ALERT SERVICE BULLETIN

429-19-43

MODEL AFFECTED: 429

SUBJECT: MAIN ROTOR MAST ASSEMBLY 429-040-011-105
LOWER SPLINE INSPECTION, INTRODUCTION OF

Figure 1 - Mast pole lower drive spline mechanical damage limits (page 1 of 2)

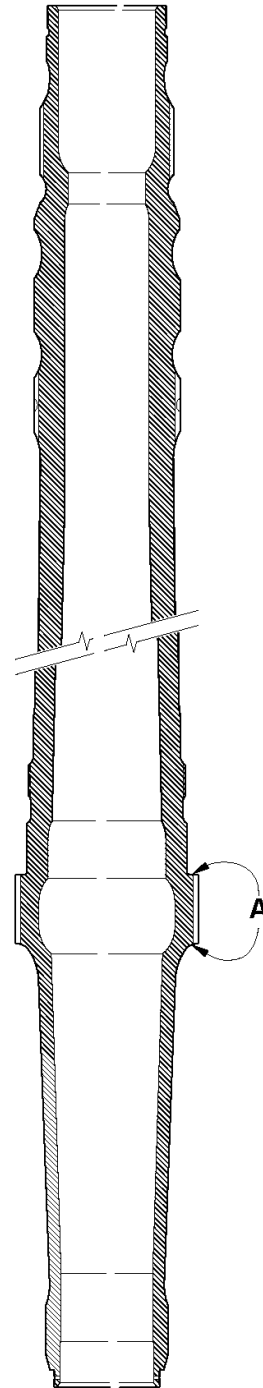
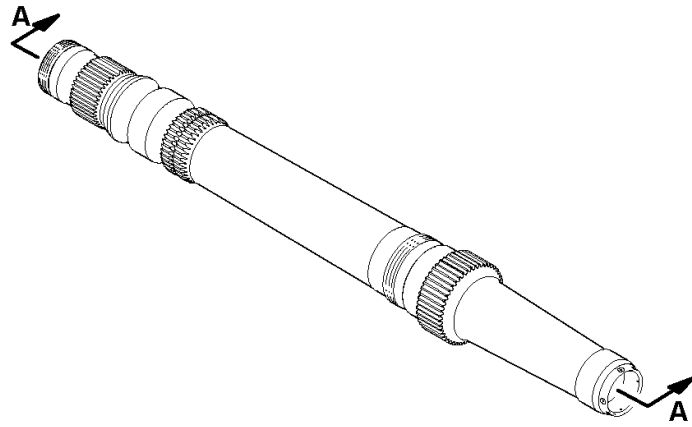
4. Inspect the main rotor mast assembly, paying particular attention to the lower drive splines. Refer to Figure 1 for damage limits.
 - a. Enter the results of the inspection in Table 1.

- b. Masts with drive spline damage beyond the limits in Figure 1 must be replaced with a new 429-040-040-105S mast pole assembly.
5. Inspect the splined adapter 429-040-301-101 paying particular attention to the inner splines. Refer to Figure 2 for damage limits.

NO.	REF LTR	CHARACTERISTIC	INSPECTION METHOD	LIMIT
1.	A	Mechanical damage	Visual/measure	Pitting or missing material on the tooth face up to 0.010 inch deep is allowable as long as any pits found are no wider than 0.050 inch. Within any 0.50 inch length of the tooth, the pits shall not exceed 25% of the area of the tooth face and shall not extend below 0.120 inch from the top of the tooth.

Figure 2 - Splined shaft mechanical damage limits

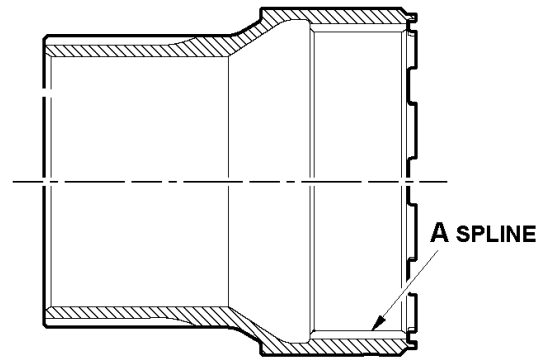
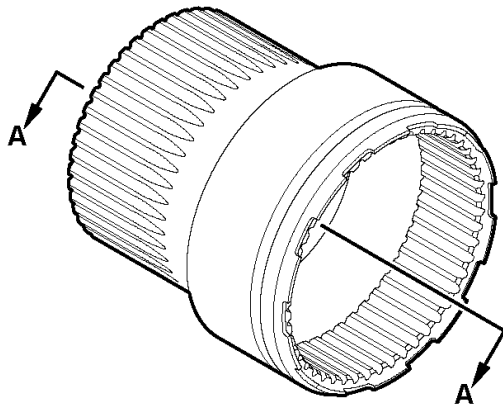
- a. Enter the results of the inspection in Table 1.
 - b. Splined adapters with inner spline damage beyond the allowable limits in Figure 2 must be replaced with a new 429-040-301-101 splined adapter.

NO.	REF LTR	CHARACTERISTIC	INSPECTION METHOD	LIMIT
1.	A	Mechanical damage	Visual/measure	Pitting or missing material on the tooth face up to 0.010 inch deep is allowable as long as any pits found are no wider than 0.050 inch. Within any 0.50 inch length of the tooth, the pits shall not exceed 10% of the area of the tooth face and shall not extend below 0.120 inch from the top of the tooth. △ 1

△ 1 It is acceptable to have the silver plate worn away in the spline tooth contact pattern area. Flaking of silver plating at the edge of the tooth contact pattern is a normal and acceptable condition.
